ADDENDUM NO. 1

DATE: **March 30, 2026**
OWNER: **Town of Tignall**
PROJECT: **Wastewater Treatment Plant Improvements**
C & S PROJECT NO.: **T7040.003**

**WWTP IMPROVEMENTS
FOR THE
TOWN OF TIGNALL
WILKES COUNTY, GEORGIA**

MODIFICATIONS TO EXISTING
AERATION POND C PLAN
SCALE: 3/32" = 1'-0"

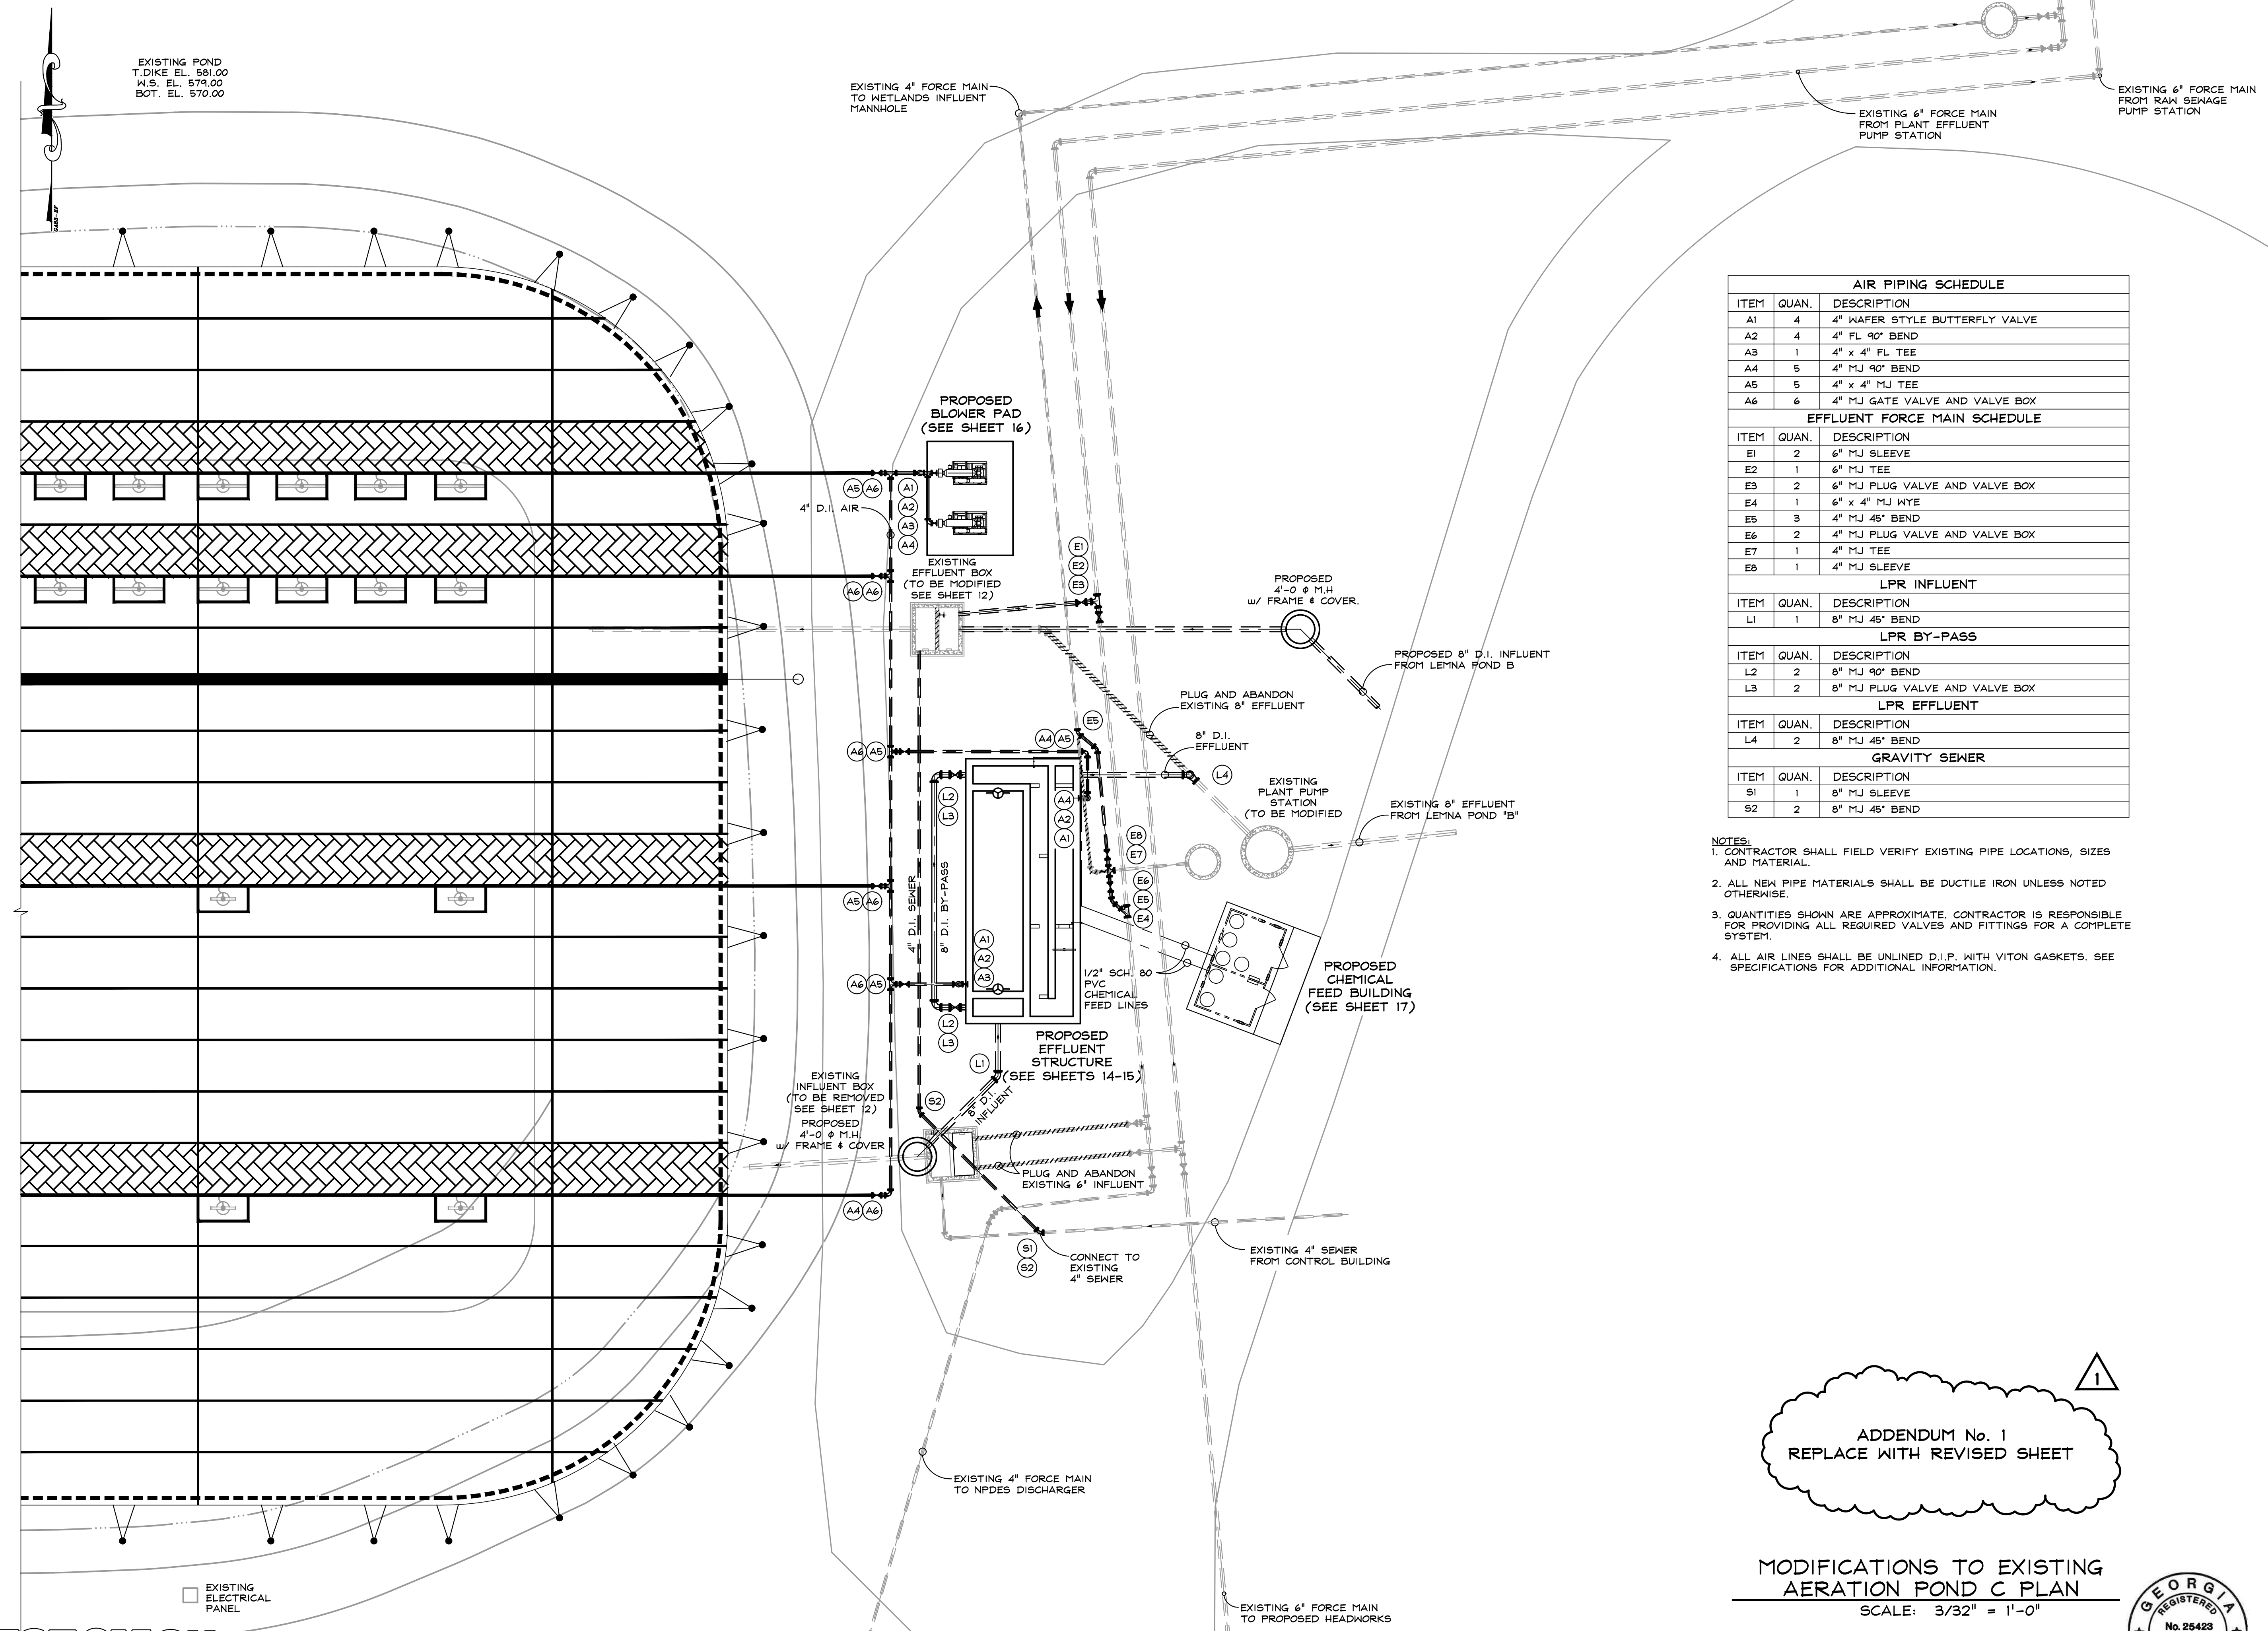
ADDENDUM No. 1
REPLACE WITH REVISED SHEET

SECTION B-B

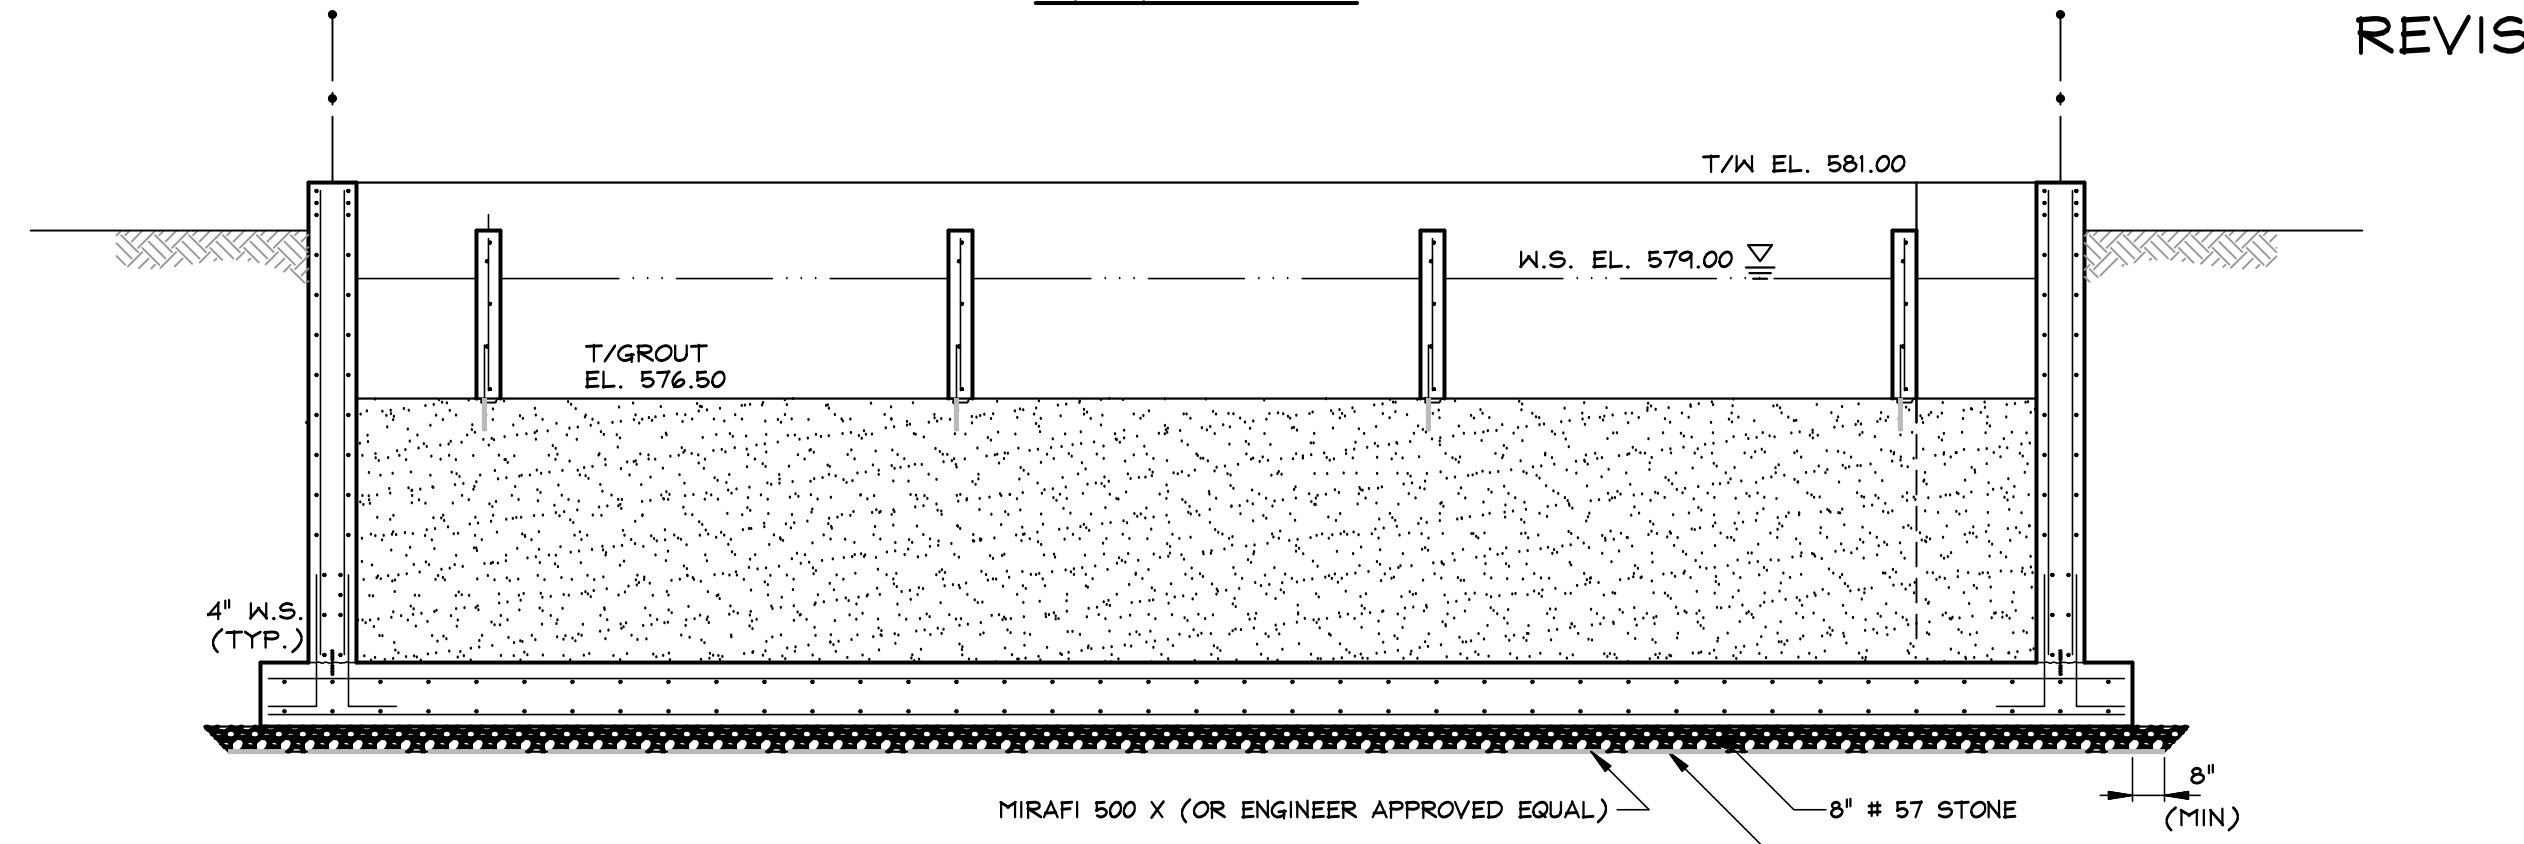
ADDENDUM No. 1
REVISE BY-PASS AND SEWER LOCATION

MODIFICATIONS TO EXISTING AERATION BASIN LAYOUT

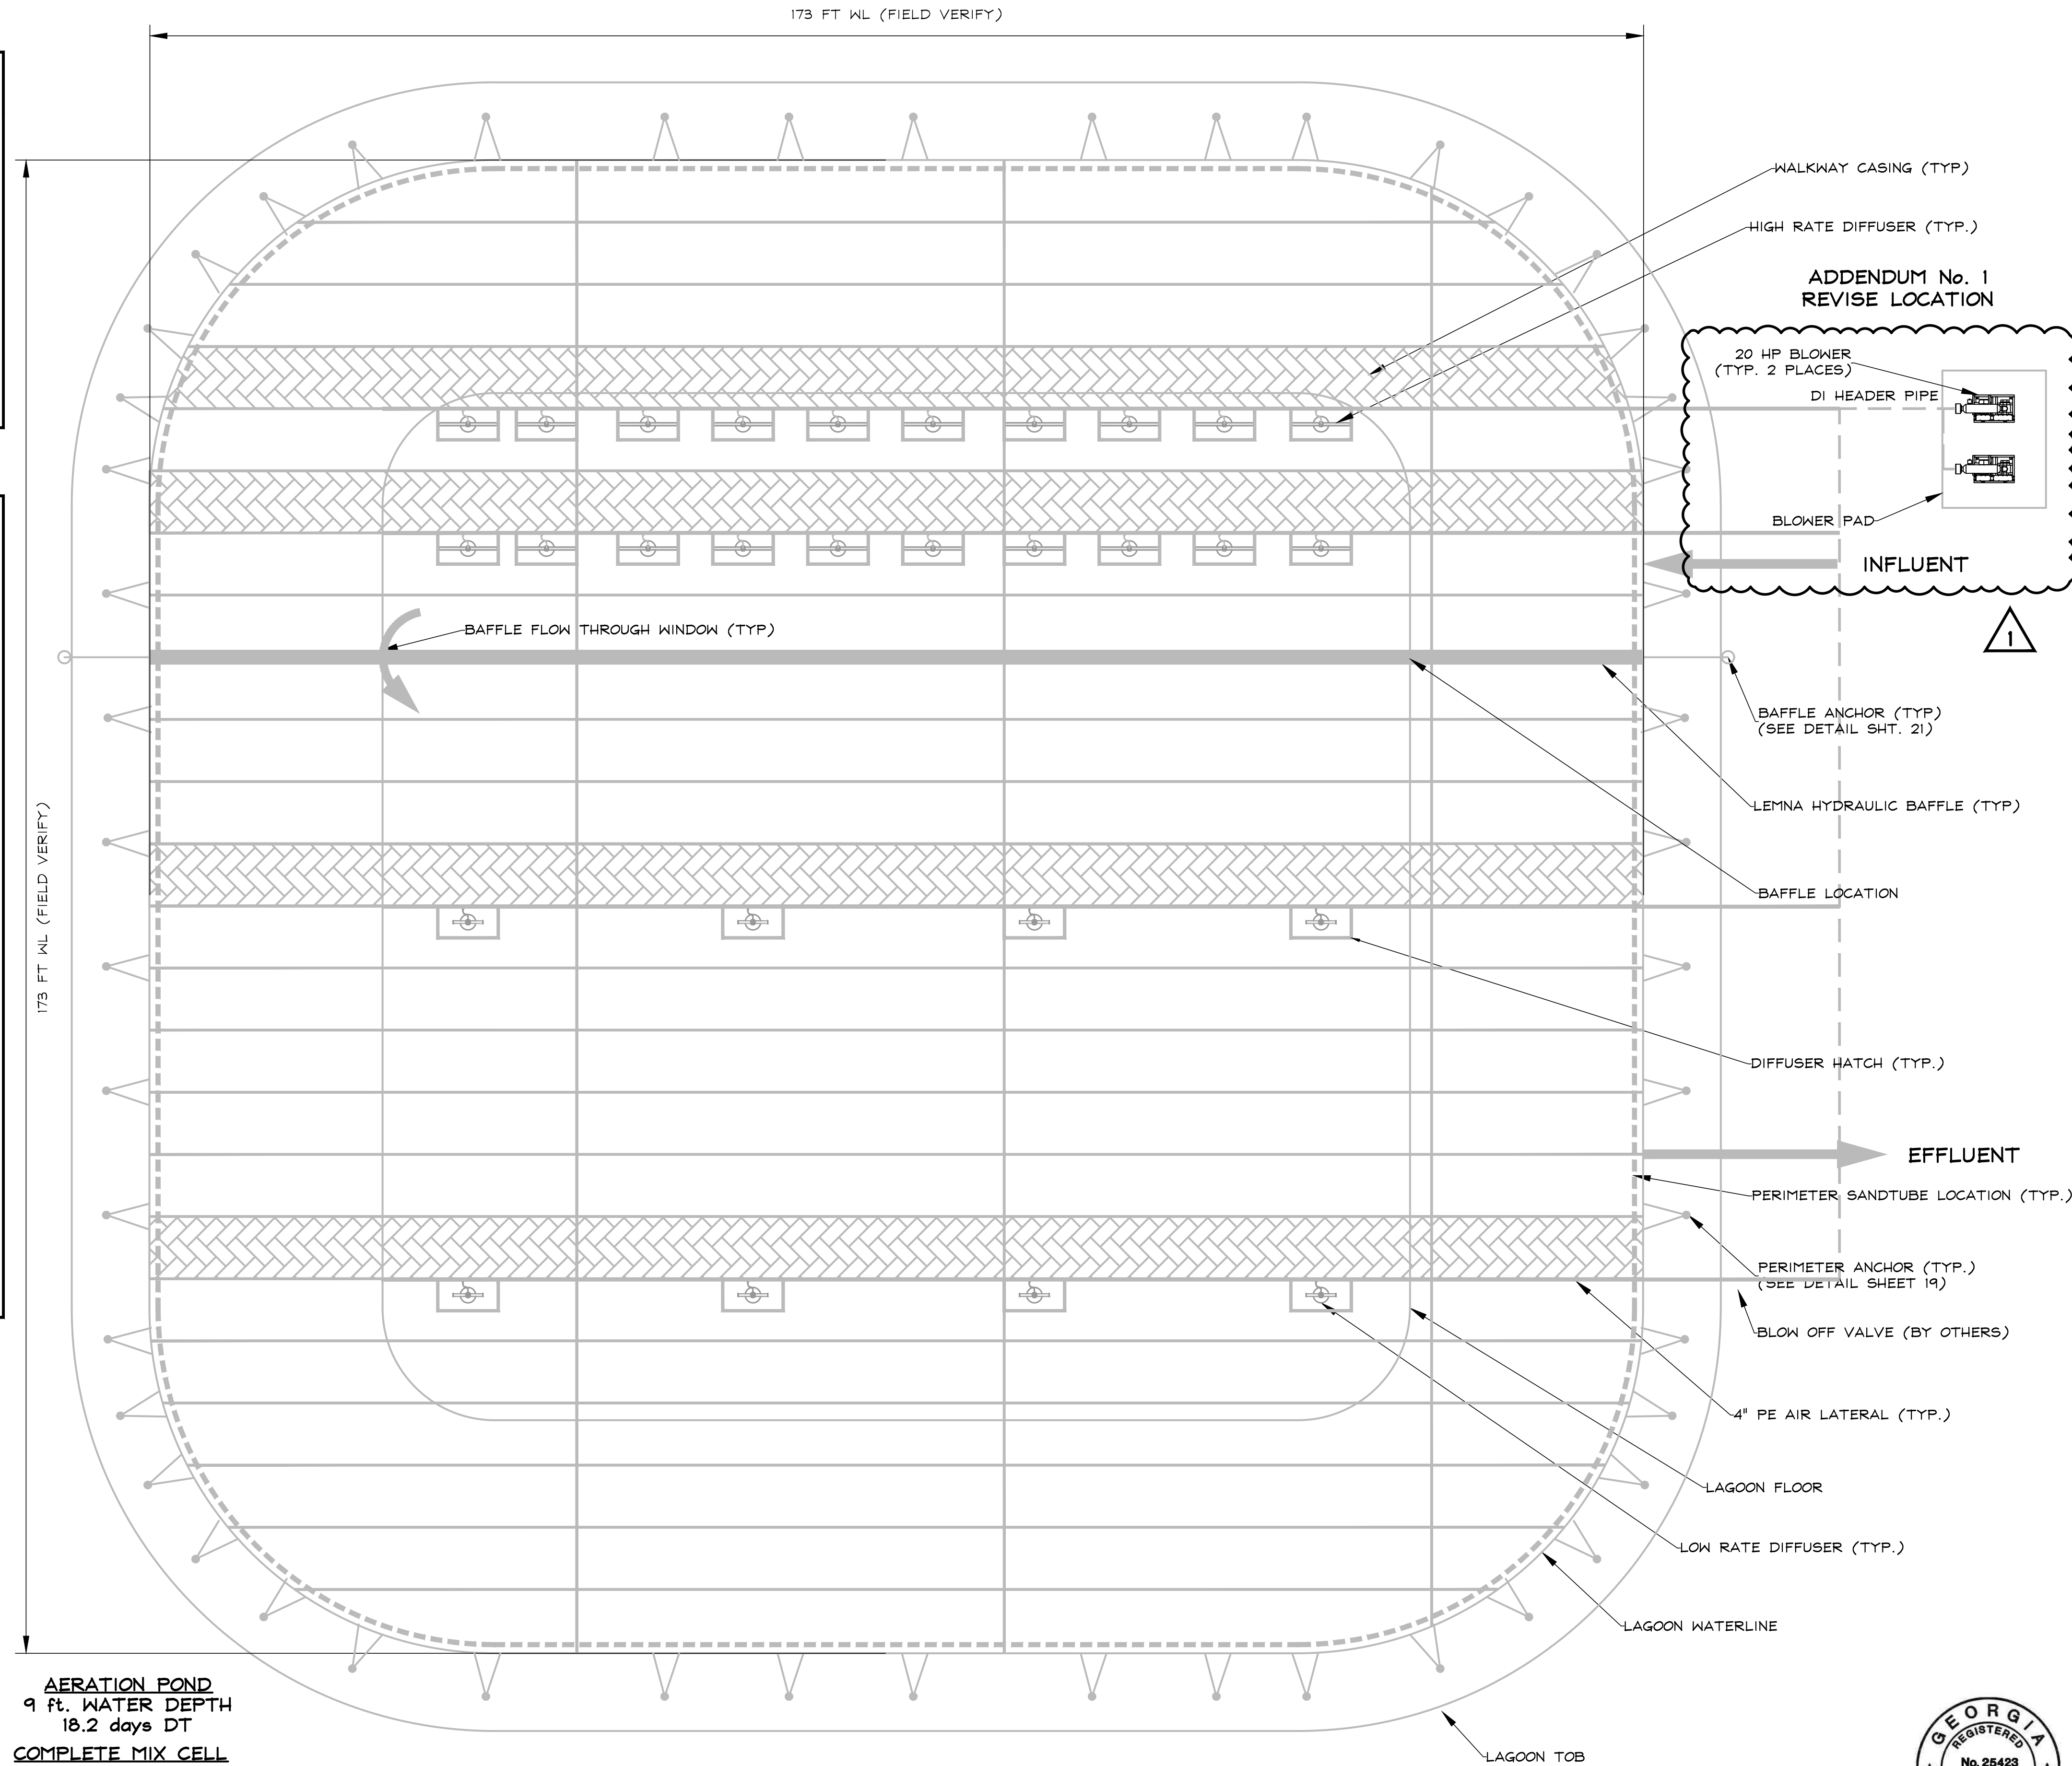
6. **Question:** Dredging the pond will not remove all the biosolids, is 8" – 12" remaining acceptable?
Answer: See revised language in Section 02325 included below in this addendum.

- CONTRACTOR MAY USE MECHANICAL OR HYDRAULIC DREDGING METHODS TO REMOVE ACCUMULATED SLUDGE FROM THE COMPLETE MIX AERATION POND. THE SLUDGE SHALL BE REMOVED AND MAY BE TRANSPORTED TO THE IDENTIFIED STAGING AREA ONSITE FOR DEWATERING. CONTRACTOR SHALL DEWATER THE SLUDGE TO SPECIFIED CAKE SOLIDS PERCENTAGE. CONTRACTOR SHALL PROVIDE NECESSARY EQUIPMENT AND CONTAINERS TO TRANSPORT THE DEWATERED SLUDGE TO AN APPROVED LANDFILL. IN ORDER TO PREVENT UNINTENTIONAL SPILLAGE OF SPOIL MATERIAL DURING TRANSPORTATION, TRUCK BED/TRAILER TAILGATES SHALL BE EQUIPPED WITH A GASKET AND A PNEUMATIC ACTUATOR AND LOCKING MECHANISM, OR A LATCH WITH CLEVIS AND BRACKET ENHANCED WITH EITHER TURNBUCKLES OR CHAIN AND BINDER TO ASSURE A POSITIVE SEAL OF THE TAILGATE TO THE BED/TRAILER.

- CONTRACTOR MUST PROTECT THE CLAY LINER DURING DREDGING OPERATIONS. ANY DAMAGE TO THE LINER MUST BE REPAIRED BY THE CONTRACTOR.
- THE CONTRACTOR SHALL, EITHER THROUGH USE OF TEMPORARY BAFFLES OR BY CLOSING THE STRUCTURE'S SHEAR GATES, ENSURE THAT EFFLUENT LEAVING THE LAGOON REMAINS REASONABLY FREE OF SOLIDS THAT MAY BE STIRRED UP DURING DREDGING.
